APPLICATION NO.	FILING DATE	FIRST NAMED INVENTOR	ATTORNEY DOCKET NO.	CONFIRMATION NO.
10/779,599	02/18/2004	Masatoshi Hizuka	KAW-317-USAP	1017

Office Action Summary

Claim 1 is objected to because of the following informalities: the language in the "optical member mounting device" clause of the claim is clumsy and difficult to easily understand. While the portion of the claim is not indefinite, the clumsy language makes it difficult to easily discern what is being explicitly claimed. Appropriate correction is required.

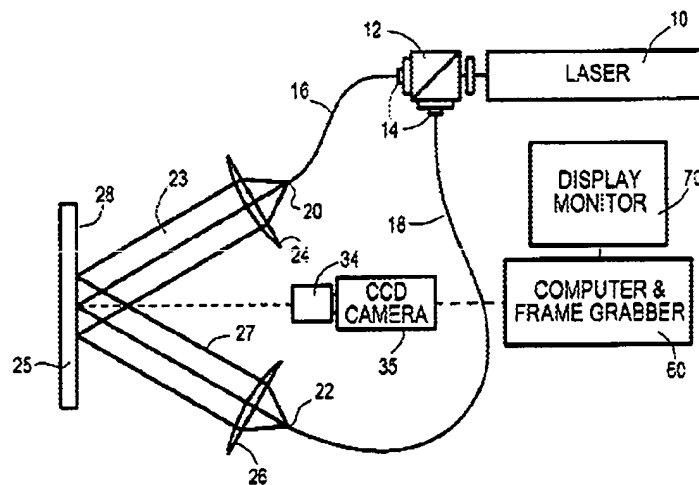
Regarding claims 1 and 3, Cloud (Fig. 1) discloses a speckle interferometer apparatus comprising a luminous flux dividing device in the form of beamsplitter 12 for dividing the luminous flux from light source 10 into two luminous fluxes, two luminous flux outputting devices in the form of fibers 16 and 18 that output light at ends 20 and 22, respectively, towards the rough surface 25 to be measured, and an imaging device in the form of lens 34 and CCD

camera 35 to capture images of the interference speckle pattern generated by light reflecting off the surface to be measured.

Cloud fails to explicitly disclose an optical member mounting device on which the light output devices are mounted and through which the camera observes the interference images.

As for claim 2, there is a predetermined optical path length difference between the optical paths due to the differing lengths of fibers 16 and 18 in the Cloud apparatus (see figure above).

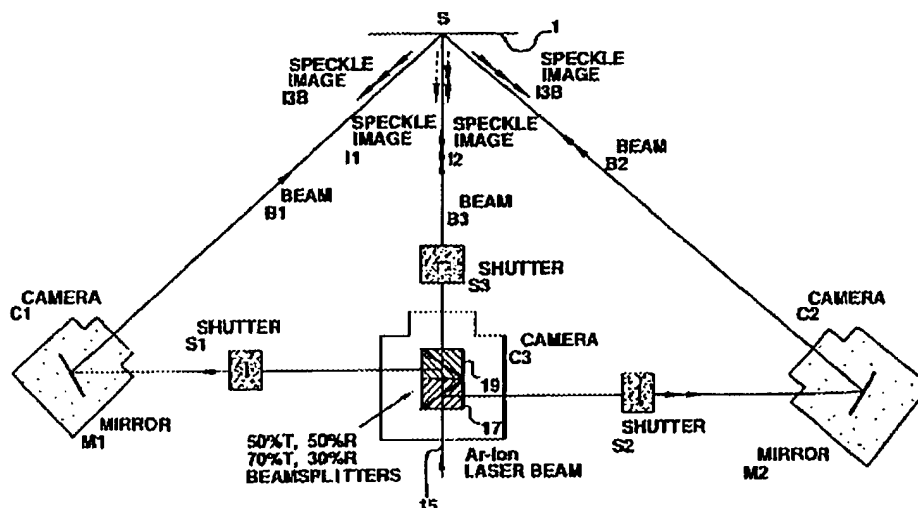
The pieces of an interferometric apparatus, however, must be attached or placed on a stable surface in order to prevent the shift of the elements of the apparatus during operation so that precise measurements may be made. Since the elements in the device are arranged two-dimensionally, a flat plate mounting device serves as the simplest mounting arrangement (claim 3).

Therefore, it would have been obvious to one having ordinary skill in the art at the time the invention was made to mount the light output devices of Cloud on an explicit optical member mount with the imaging device between the output devices, the motivation being that such a mounting arrangement will provide for a smaller, more compact apparatus while maintaining stability of the elements of the device for accurate measurements.

As for claims 4-5, the light output devices of Cloud are disposed so that they oppose each other across the light-transmitting area; they come in at equal and opposite angles that are orthogonal to one another (claim 5) on each side of the imaging device.
